**Study Area Characterization Work Plan Addendum Number 1
Additional Field Investigation Activities**

Site Name and Location:	Study Area, Corning, NY
Order on Consent and Administrative Settlement:	NYSDEC Project ID 851046
Corning Incorporated Project Coordinator:	Mike Ford
NYSDEC Project Coordinator:	Gregory B. MacLean
Date:	October 24, 2014

**RE: Study Area Characterization Work Plan Addendum Number 1 -
Additional Field Investigation Activities; and
Groundwater Wells proposal
Study Area, Project No. 851046
Corning (C), Steuben (Co)**

Figure 3
 Sample Locations
 Residential Area

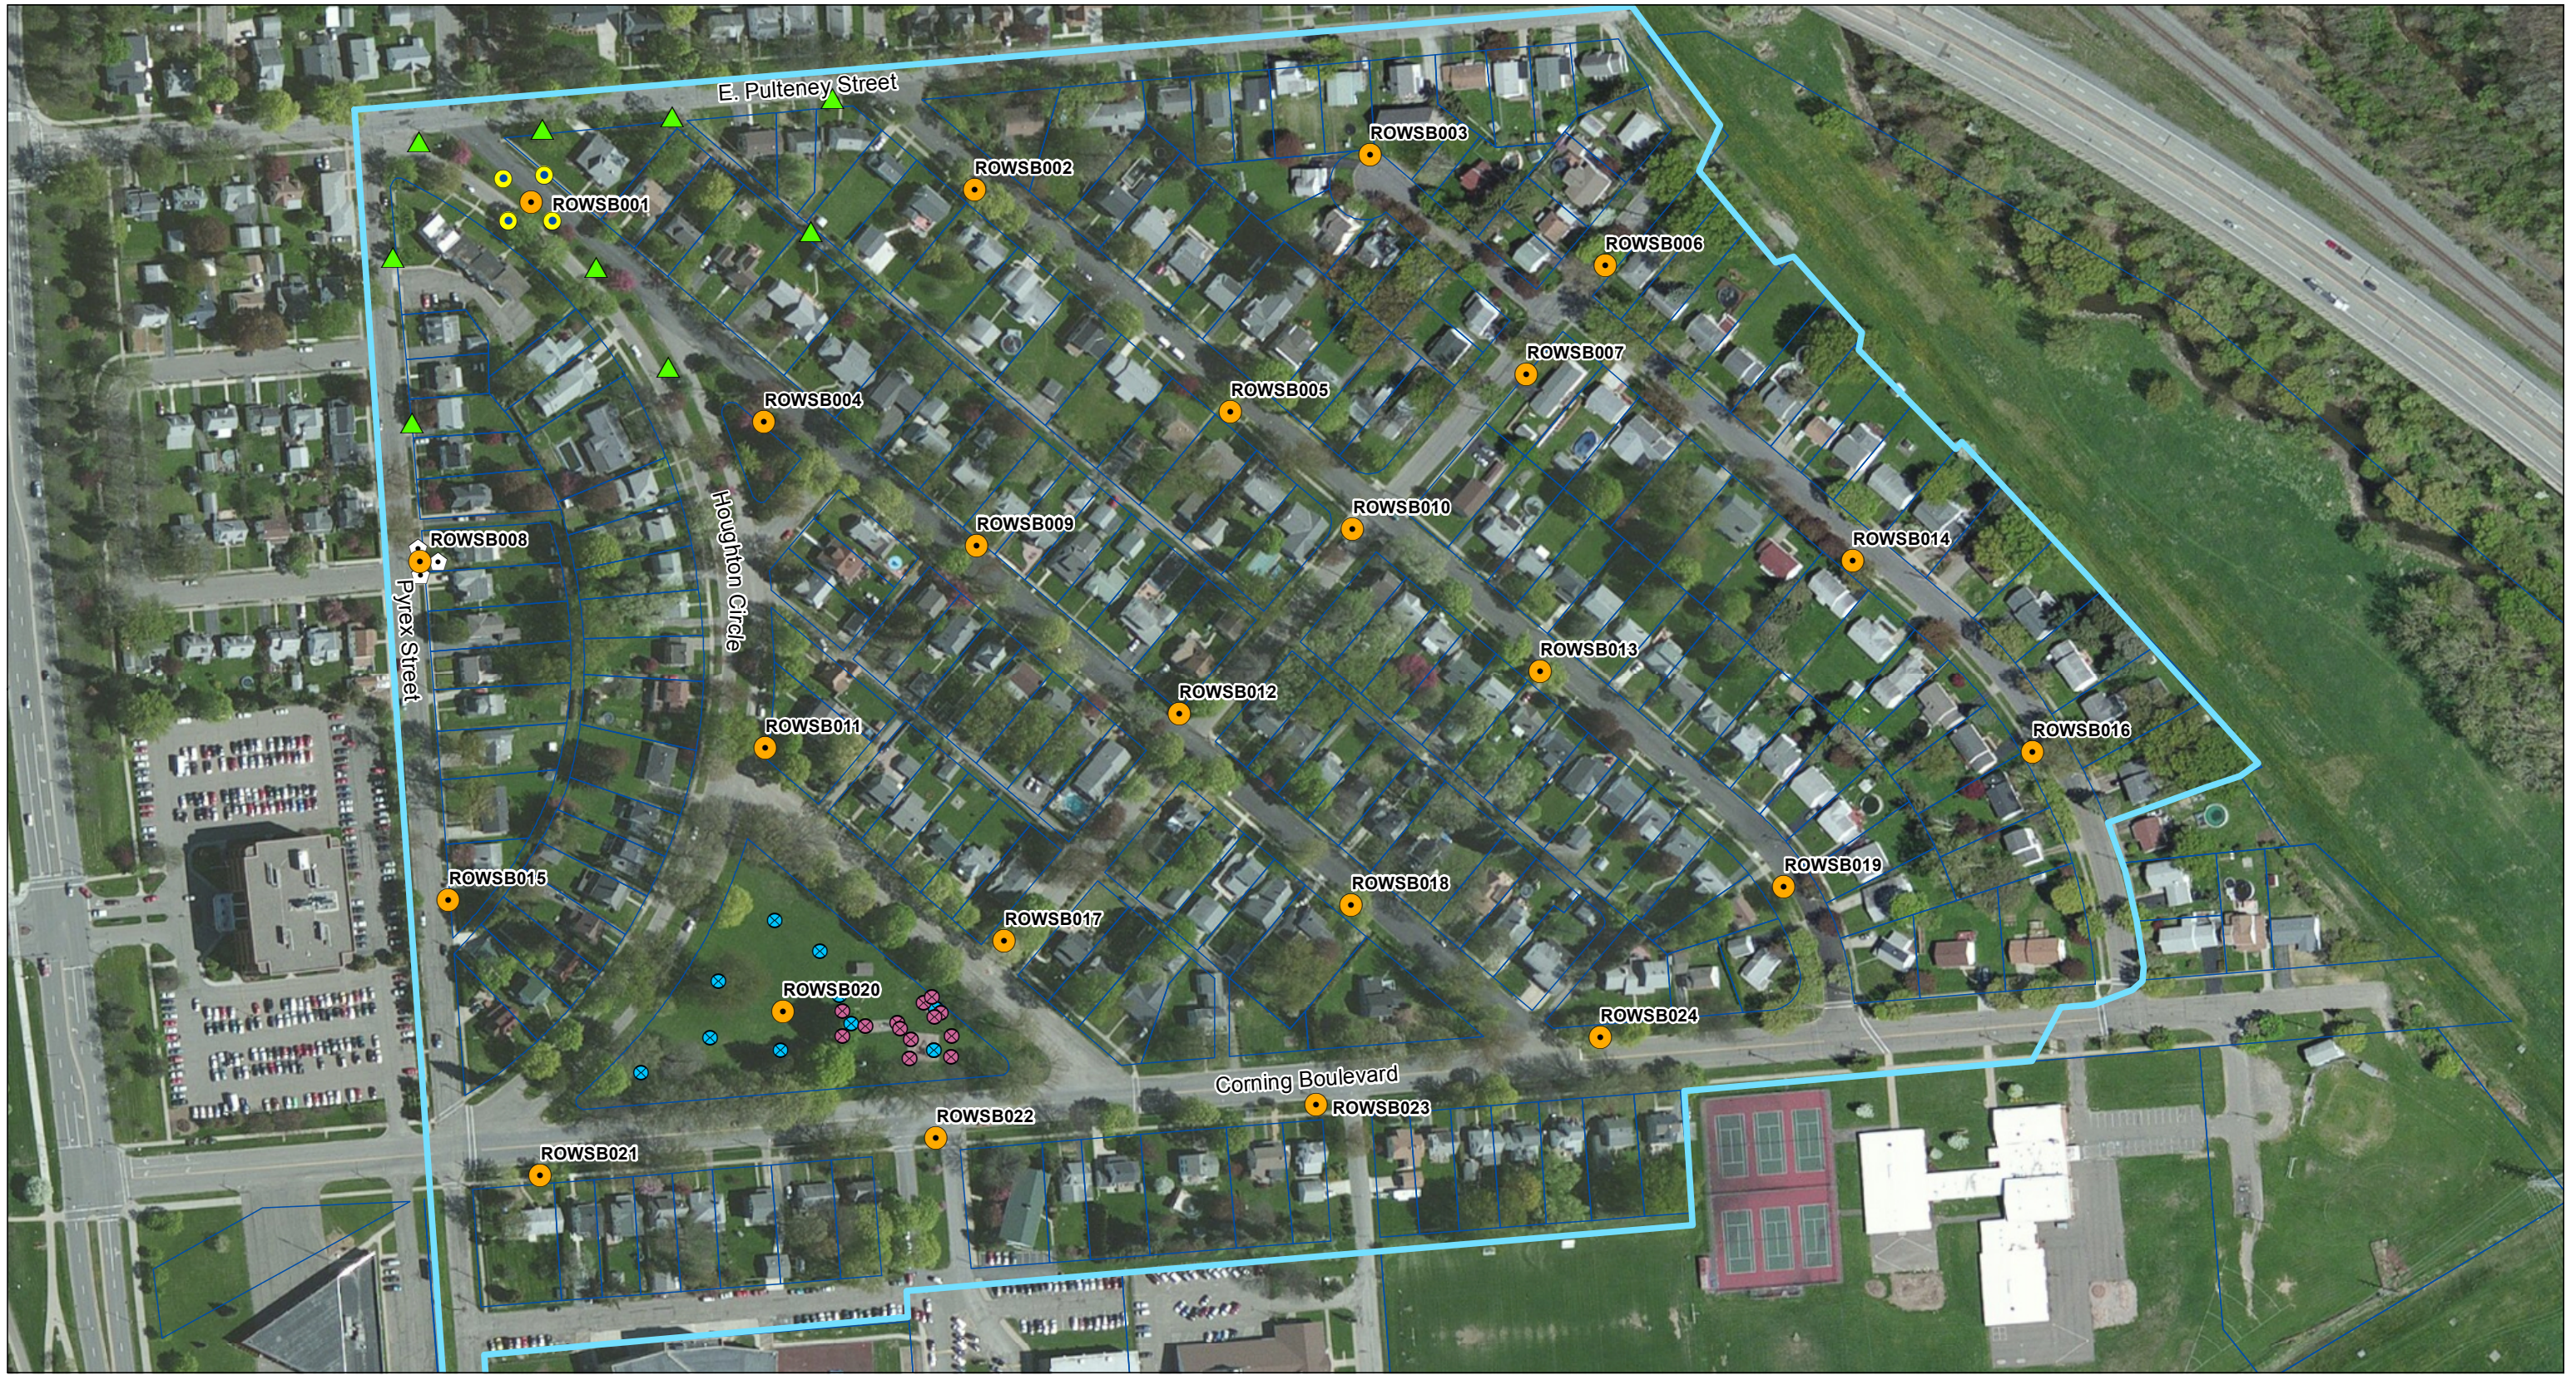
Based on preliminary, un-validated analytical data for soil samples collected from soil boring ROWSB001 in the Residential Area four (4) additional soil borings are proposed to be installed in the City of Corning right-of-way to assess the horizontal extent of fill material encountered within the vicinity of this soil boring. The locations of the proposed additional soil borings in the Residential Area are shown on Figure 3 attached and described below.

- Two (2) soil borings will be installed in the median strip along Houghton Circle, one approximately 50 feet northwest and one approximately 50 feet southeast of the location of soil boring ROWSB001.
- Two (2) soil borings will be installed, one on either side of the roadway, within the City of Corning right-of-way, northeast and southwest of the location of soil boring ROWSB001.

If fill material containing ash, brick, and glass pieces are encountered during the soil borings, up to nine (9) additional soil borings will be installed, within the City of Corning right-of-way, at the locations shown on Figure 3 attached to determine the horizontal extent of the fill material.
